AMENDMENTS TO THE DRAWINGS:

REMARKS

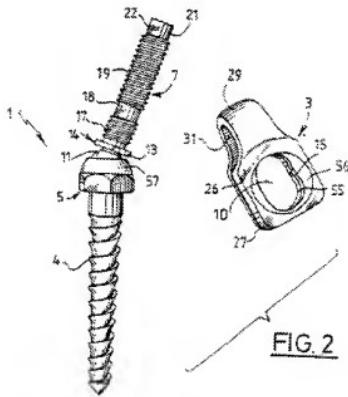
The drawings were objected to for not showing the "intermediate part" recited in the claims.

The attached sheet of drawings includes changes to add Figure 6A. Figure 6A shows a generic illustration of intermediate part 39. As the intermediate part 39 is illustrated generically, no new matter is entered.

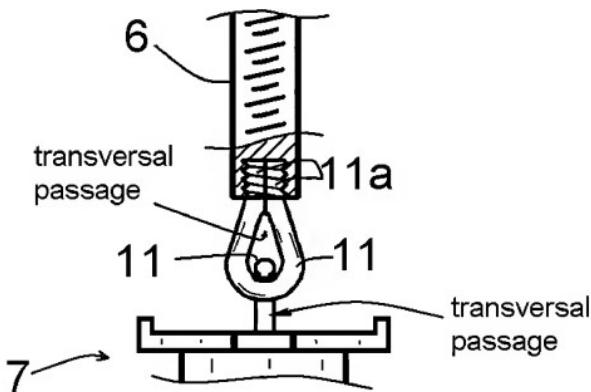
Reference can be made to US 6,267,765 which shows a "polyaxial" anchoring element 1 with a threaded proximal stud (shaft) 7 articulated with respect to an anchoring base part 4:

With the existing elements, the drawbacks are: limited play of the proximal slug or tulip part, conducting to difficulties for mounting, diffusion of metal particles in the

body, and complete rigidity of the equipment, which is not always desirable.

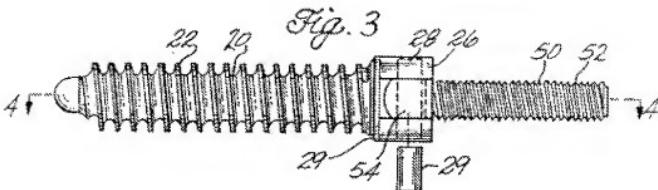
Each screw comprises a base part 20 and a connecting part 50; the base part 20 includes a pair of ears 26 with holes 28, and the connecting part 50 includes a loop 54 having an aperture 56, this connecting part 50 being pivotally mounted on the base part 20 by means of a pin 29 inserted in the holes 28 and the loop 54.

It is indicated (column 3, lines 13-14) that the aperture 56 of the loop 54 is slightly larger than the diameter of the pin 29 so that the swing bolt 50 can pivot around the pin

29. It appears moreover on the figures that ring 54 is engaged in an adjusted way between the ears 26, see in particular figure 3:

The Official Action states that HOWLAND discloses a "polyaxial" screw, which is not correct. A polyaxial screw is a screw in which the proximal part is articulated, i.e., movable in a plurality of planes. On the contrary, the screw according to HOWLAND allows only a movement of pivot of the swing bolt 50, i.e. a movement in a single plane.
